# HISTORIC DISTRICT COMMISSION

# CERTIFICATE OF APPROPRIATENESS

**Application Number:** HDC2025-00655

**Project Address:** 1613 Leverette Street

NEW ALLEY SIDE ELEVATION

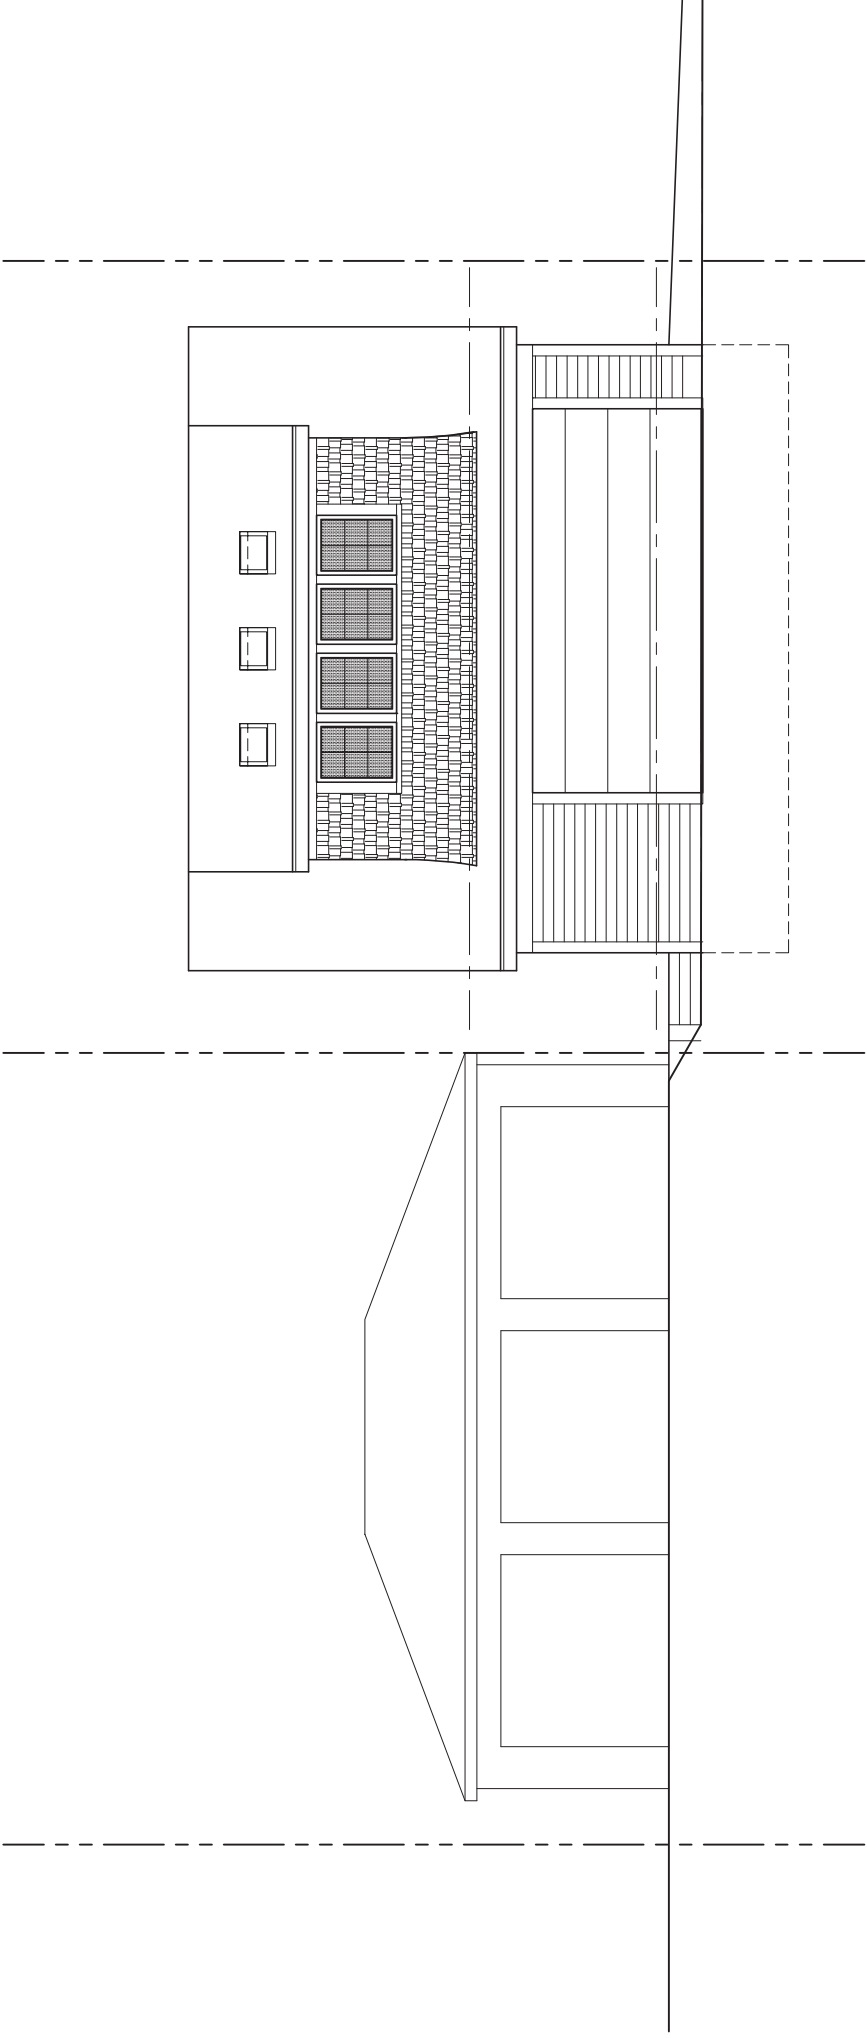
*9.) New additions, exterior alterations, or related new construction shall not destroy historical materials that characterize the property. The new work shall be differentiated from the old and shall be compatible with the massing scale, size, scale, and architectural features to protect the historic integrity of the property and its environment.*

In conjunction with the previous response, the new building was carefully designed and adopts design elements from the primary structure presenting a harmonious development that doesn't degrade the surrounding historic nature of the neighborhood. The use as a carriage house is present in many other examples the district, even at the end of the alley (1829 Leverette Street) where this project is located. In fact, 18.6% of the total structures located in the immediate districts are directly used as carriage houses, are attached garage structures (non-historic), or have massing similar to this project. It should be noted that a majority of the homes in the district do not presently have garages. This project has gone well above and beyond these existing examples to make the carriage house seem aesthetically historic in its design style.

SK1 – New and existing adjacent elevations.
